**World Forum for Harmonization of Vehicle Regulations****Working Party on General Safety Provisions****127th session**

**Amendments to Gas-Fuelled Vehicle Regulation:****UN Regulation No. 110 (Compressed Natural Gas and Liquefied Natural Gas vehicles)****Proposal for Supplement 1 to the 06 Series of Amendments to  
UN Regulation No. 110 (Compressed Natural Gas and  
Liquefied Natural Gas vehicles)****Submitted by the expert from the European Association of Automotive  
Suppliers \***

##### Example 2

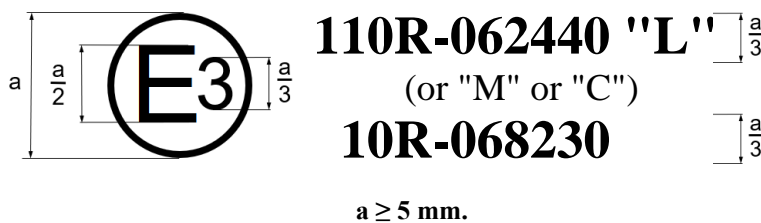
(See paragraph 7.4.3. of this Regulation)

This approval mark when affixed to the CNG and or LNG component shows that the component has been approved in Italy (E 3), pursuant to UN Regulation No. 110 under approval number 062440 and pursuant to UN Regulation No. 10<sup>1</sup> under approval number 068230. The first two digits of the first approval number indicate that the approval was granted in accordance with the requirements of UN Regulation No. 110 as amended by the 06 series of amendments.

**The letter "L" indicates that the product is suitable for use with LNG.**

**The letter "M" indicates that the product is suitable in moderate temperatures.**

**The letter "C" indicates that the product is suitable in cold temperatures.**

**The first two digits of the second approval number indicate that the approval was granted in accordance with the requirements of UN Regulation No. 10 as amended by the 06 series of amendments."**
